## **FINAL ENVIRONMENTAL IMPACT REPORT**

# **LOS ANGELES COUNTY DEPARTMENT PUBLIC WORKS DISTRICT 29 PRIORITY CAPITAL DEFICIENCIES IMPROVEMENTS**

**April 2021**

**Figure 2-12**  
**Cumulative Impact Analysis Projects**  
**Los Angeles County Waterworks District 29 - Priority Capital Deficiencies Improvements**

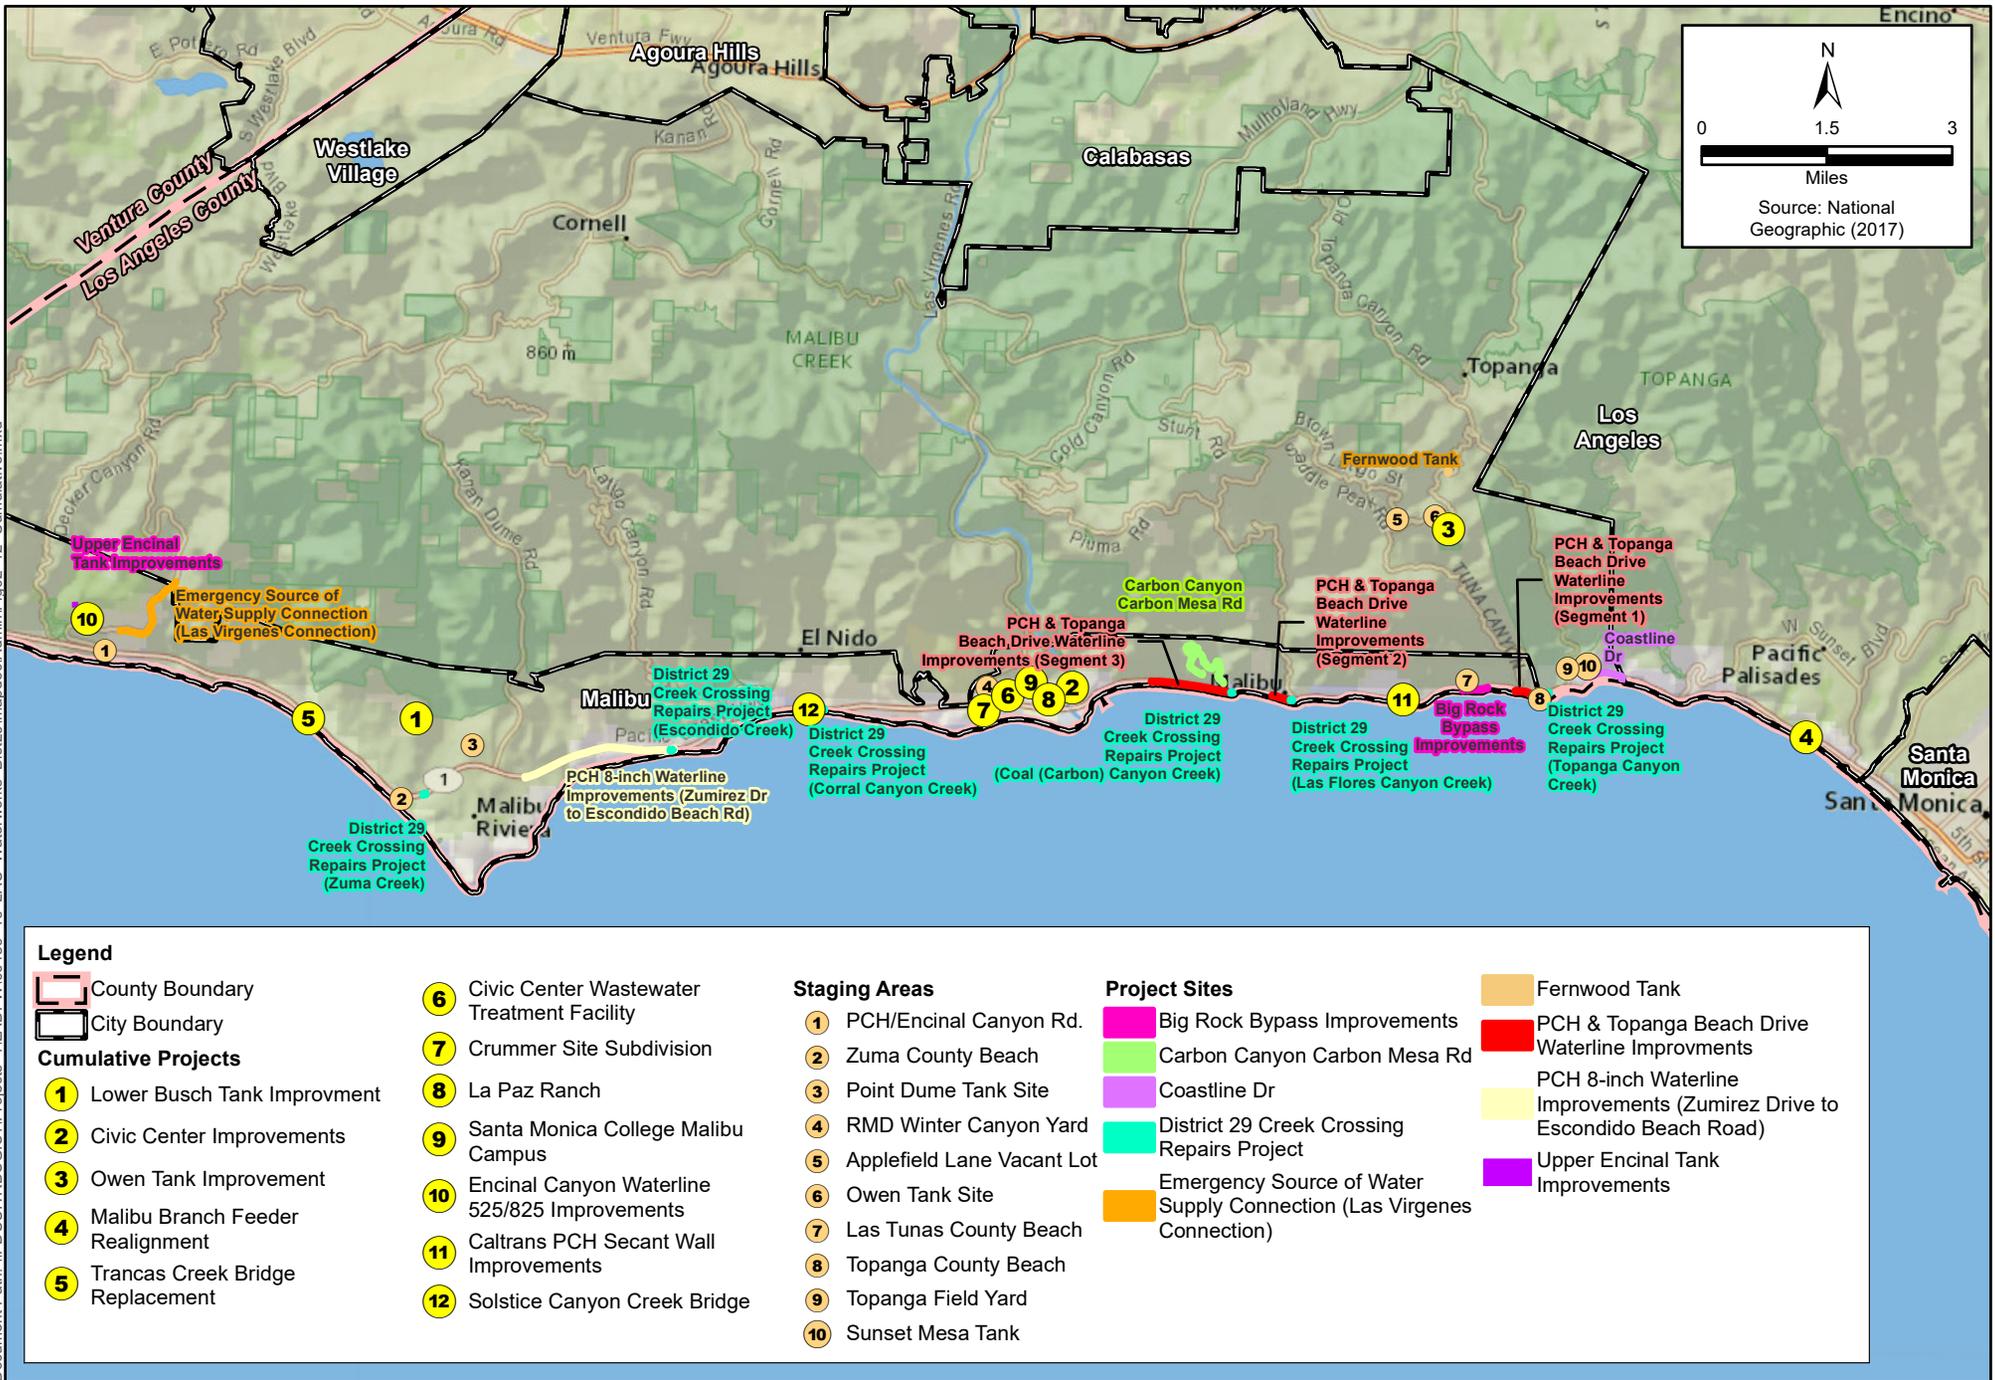
Figure 2-12, *Cumulative Impact Analysis Projects*, in Section 2.6, *Related Projects*, is revised to be consistent with revisions to Chapter 5, *Cumulative Impacts*, discussed below, by adding a related project (see revised Figure 2-12). This change does not result in substantive changes to the Draft EIR because no new or more severe cumulative impacts were identified with the changes in the dates of the Civic Center Improvements (Sweetwater) project and the additional Caltrans Solstice Canyon Creek Bridge Replacement project.
